Our Ref: 2316_ASW01

Application Reference: A006964253

Property Address: 165 Trouts Road, Stafford Heights QLD 4053

Subject: Response to Council's Information Request – Traffic Matters

CLIENT
BEAVEN GROUP
PTY LTD
TITLE
CONCEPT EARTHWORKS
SECTIONS

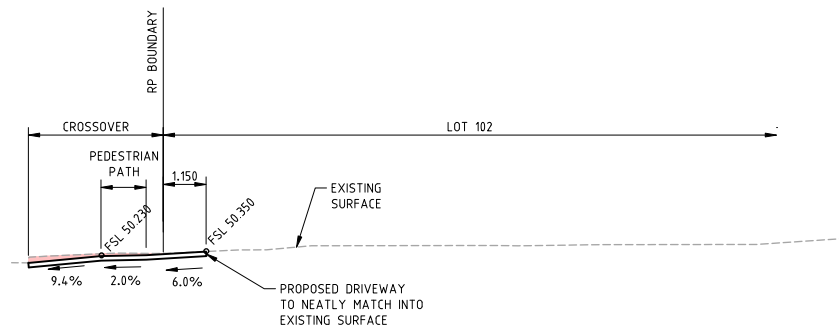
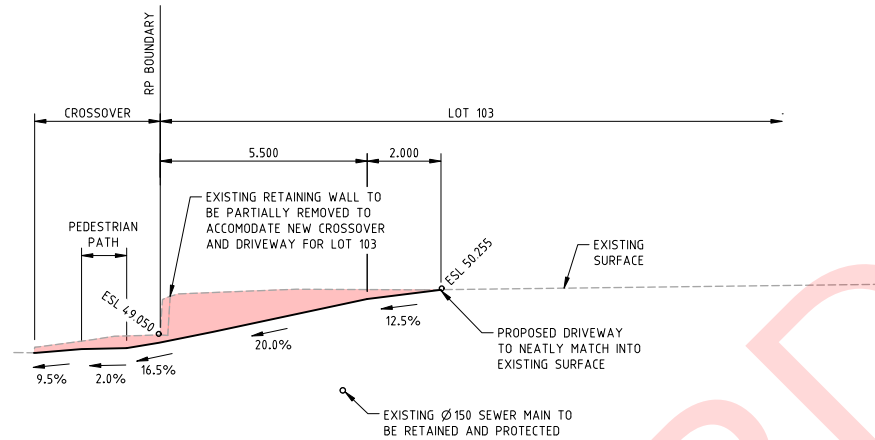
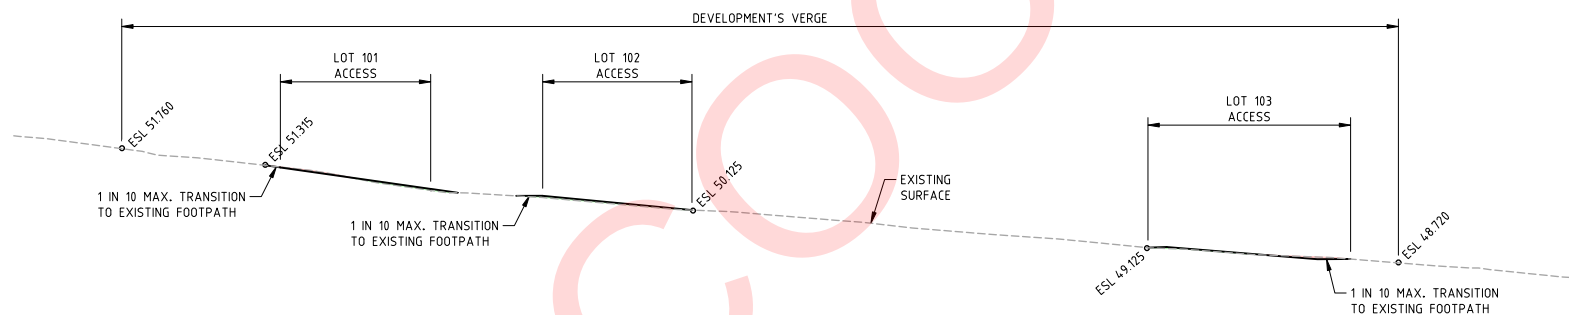
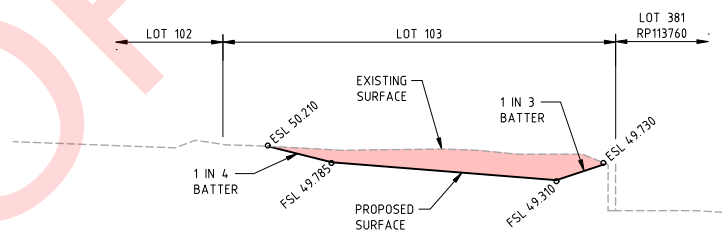
1. The development proposes separate access for each of the new lots to Trouts Road, which is classified as a major road, through areas where a significant difference in levels exists between the existing verge and existing unchanged lot level whilst no earthworks are proposed.

Given this, the proposed access arrangements are not currently supported due to being unsafe, the potential to impact on function of the road network and the inability to access a usable building pad.

- iv. The earthworks required within each lot to provide suitable access from any crossovers to the building pad. Ensure maximum grades of access do not exceed those shown on Brisbane Standard Drawing BSD-2024/2025 and provide all details / sections of earthworks to facilitate these accesses. Existing surface is to remain as is within the verge.

The civil plans included as **Attachment 1** document the proposed access arrangements and earthworks required to access each of the three (3) proposed lots, which can be summarised as follows:

- **Proposed Lot 1:** the provision of a crossover towards the southern site boundary which generally follows the existing kerb profile. A small area of cut is proposed to the north of the driveway and a small area of fill is proposed to the south of the driveway to tie into the existing verge levels. No earthworks within the site are proposed or required to achieve the building pad level, which will be approximately RL50.5.

- **Proposed Lot 2:** the provision of a crossover towards the northern site boundary which generally follows the existing kerb profile. A small area of fill is proposed to the north of the driveway to tie into the existing verge levels. Minor earthworks within the site are proposed to achieve the building pad level, which will be approximately RL50.35. These works will however be contained to the driveway area.

- **Proposed Lot 3:** the provision of a crossover towards the southern site boundary which generally follows the existing kerb profile. A small area of fill is proposed to the north of the driveway and a small area of cut is proposed to the south of the driveway to tie into the existing verge levels. Earthworks within the site are proposed to achieve the building pad level, which will be approximately RL50.255.
